UNITED STATES PATENT AND TRADEMARK OFFICE

| APPLICATION NO. | FILING DATE | FIRST NAMED INVENTOR | ATTORNEY DOCKET NO. | CONFIRMATION NO. |
|-----------------|-------------|----------------------|---------------------|------------------|
| 10/821,860 | 04/12/2004 | Federico Cabrele | 713-1121 | 1818 |

Office Action Summary

DETAILED ACTION

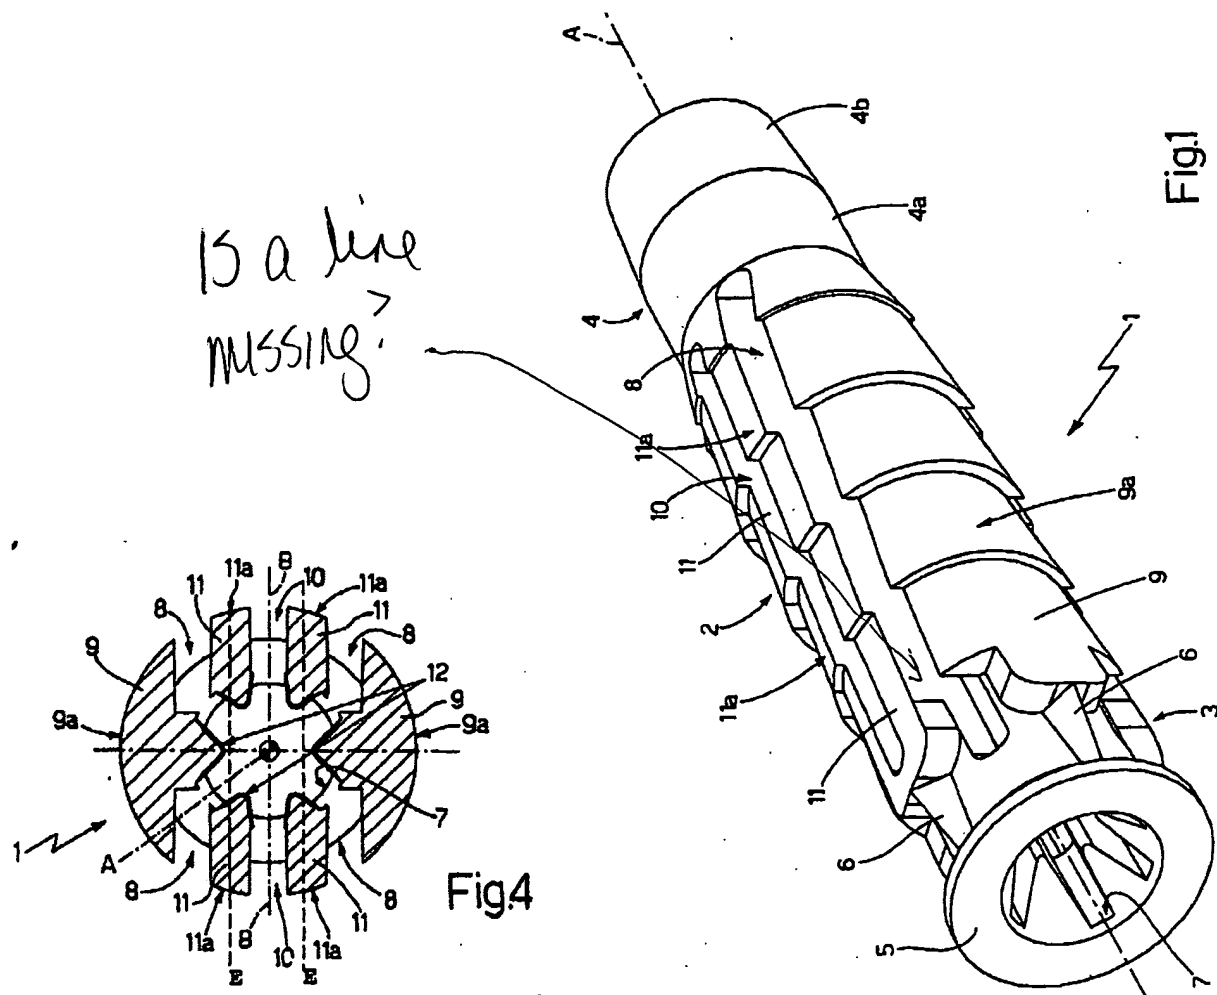
1. The drawings are objected to because examiner does not see how Fig 1 corresponds with Fig 4. Note that Fig 4, for example, clearly shows that secondary tongue 11 has a "thickness" or "depth" (material dimension from outer circumference toward axis A), but this is not clear in Fig 1 -- perhaps a line is missing.

Also, In Fig 1 above, "11" is used to point to both a secondary tongue and a slot?

Corrected drawing sheets in compliance with 37 CFR 1.121(d) are required in reply to the Office action to avoid abandonment of the application. Any amended replacement drawing sheet should include all of the figures appearing on the immediate prior version of the sheet, even if only one figure is being amended. The figure or figure number of an amended drawing should not be labeled as "amended." If a drawing figure is to be canceled, the appropriate figure must be removed from the replacement sheet, and where necessary, the remaining figures must be renumbered and appropriate changes made to the brief description of the several views of the drawings for consistency. Additional replacement sheets may be necessary to show the renumbering of the remaining figures. Each drawing sheet submitted after the filing date of an application must be labeled in the top margin as either "Replacement Sheet" or "New Sheet" pursuant to 37 CFR 1.121(d). If the changes are not accepted by the examiner, the applicant will be notified and informed of any required corrective action in the next Office action. The objection to the drawings will not be held in abeyance.

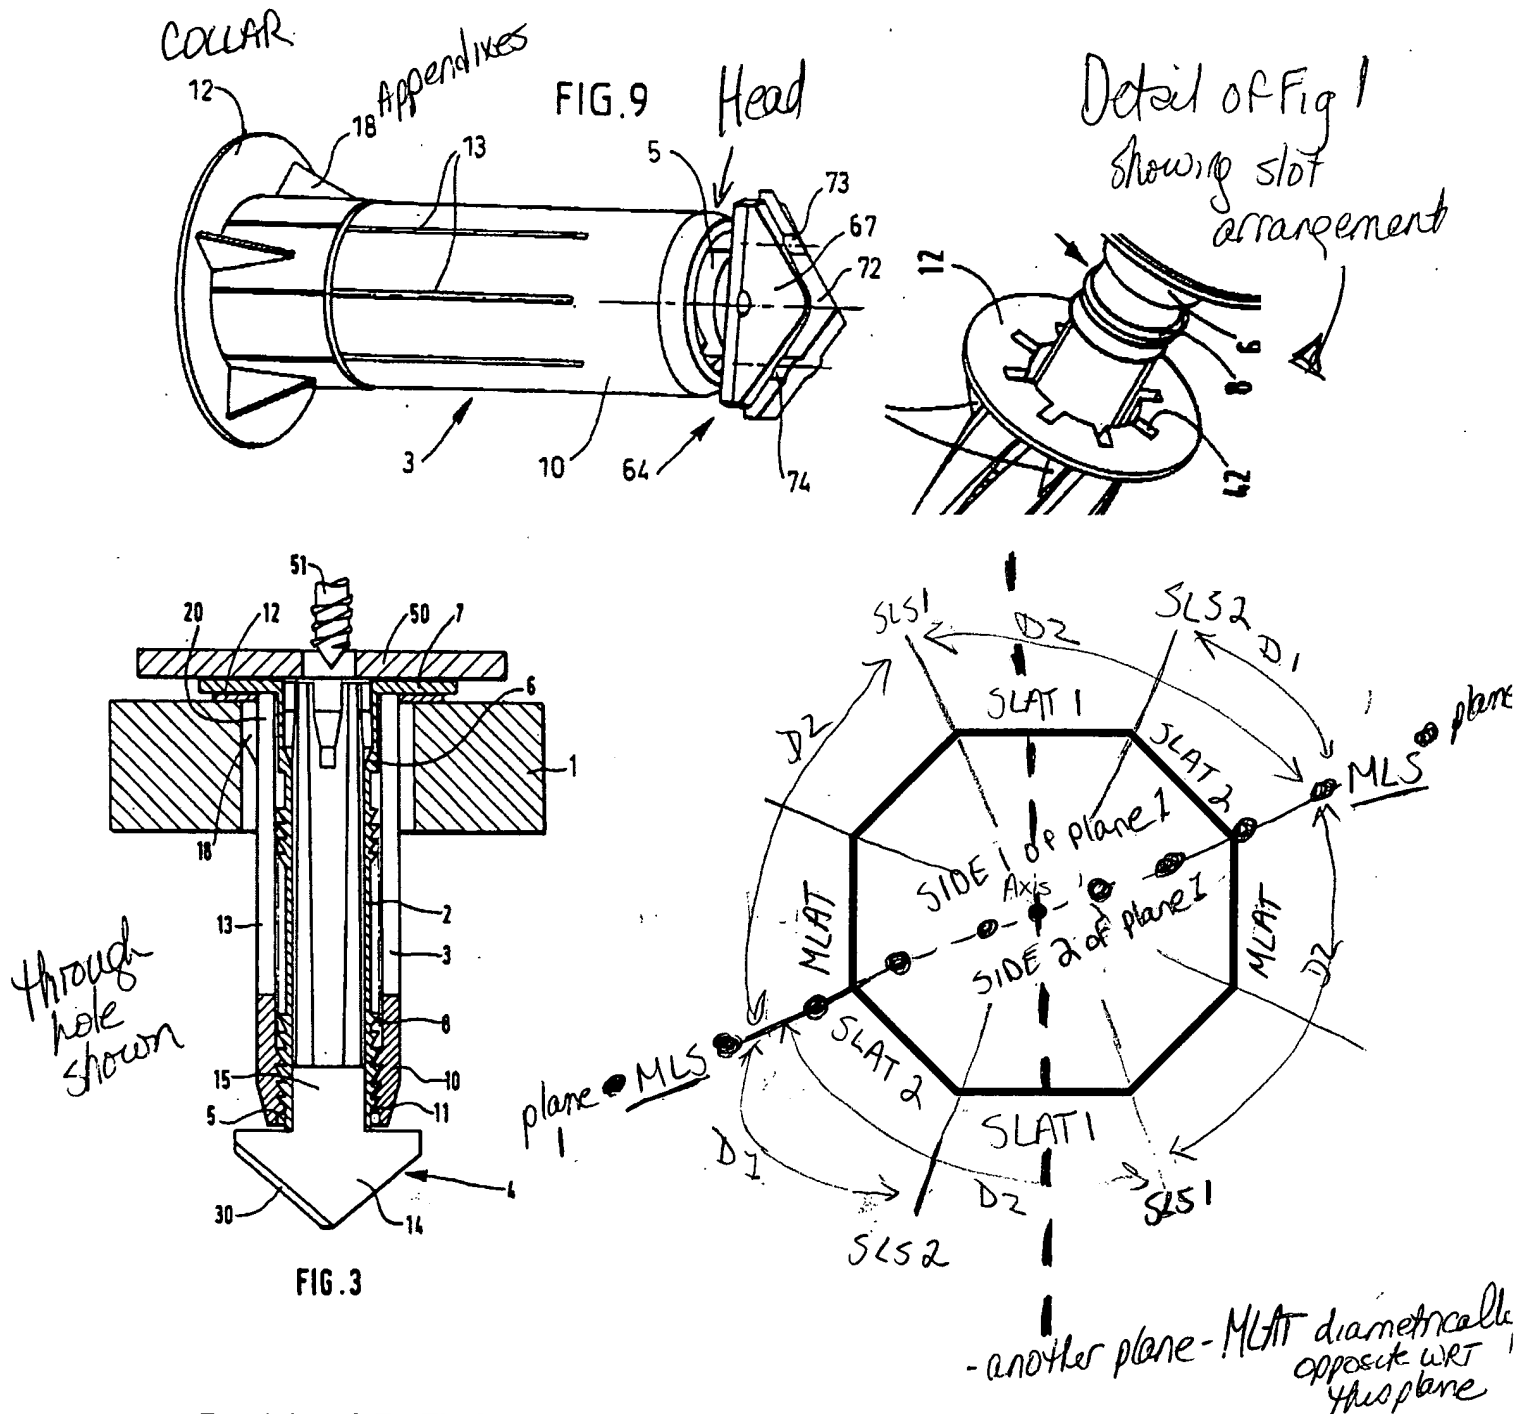
Re claims 1, 14: Vernet shows a screw anchor (3) with a deformable (expandable -abstract) central portion in which main longitudinal slots (MLS) (4 of the slots labeled "13") are formed, and further comprising secondary longitudinal slots (SLS) (the remaining 4 of the slots labeled "13") formed in said central portion. Examiner notes that 4 of the slots (13) are considered main (MLS) and the balance are considered secondary (SLS). The main longitudinal slots MLS extend essentially parallel to a plane on which a longitudinal axis of the screw anchor lies, and define deformable main longitudinal anchoring tongues (MLAT) which lie on opposite sides of the plane. Currently the embodiment of Fig 9 is being applied since it is clearer. However, note col 3 line 66 - col 4 line 2, which explicitly states that the slots 13 are in planes which may be inclined with respect to the axis OR which pass through the axis as in Fig 3. However, Fig 9 shows this most clearly, and note that col 5 lines 12-18 specifies that the only difference in the first and 2nd embodiments is the piercing means of the pin body -- the sleeve {anchor} are the same.

Re claim 3: Pairs of main longitudinal slots (MLS) define main longitudinal anchoring tongues (MLAT) (strip between two "13's". There are 8 equally-spaced slots "13"
from (see detail of Fig 1 below)

per Fig 1 below) - examiner has labeled an octagon below, with each corner representing a slot, with which slots are considered main and which are considered secondary.

Re claims 8-9: As best understood, referring to the numbering by examiner of the octagonal shape, representing the collar with 8 slots of Vernet, there are 4 SLS arranged in 2 pairs that are arranged in mirror image relationship with each other, and the SLS of each pair are parallel. Since examiner does not know of that there are "the slots of each pair" {implying at least 4??}, examiner is not sure what is being described. However, note equivalent Distances D1 and D2 on octagonal drawing, with each slot of pair SLS1 having equal distances from MLS as each slot of pair SLS2.

Further re claim 14: Deformable main longitudinal anchoring tongues (MLAT) are arranged diametrically opposite one another with respect to the longitudinal axis of the anchor, and secondary longitudinal anchoring tongues (SLAT) are arranged in essentially mirror image pairs in which each pair is arranged diametrically opposite the longitudinal axis. (see marked up drawing above)
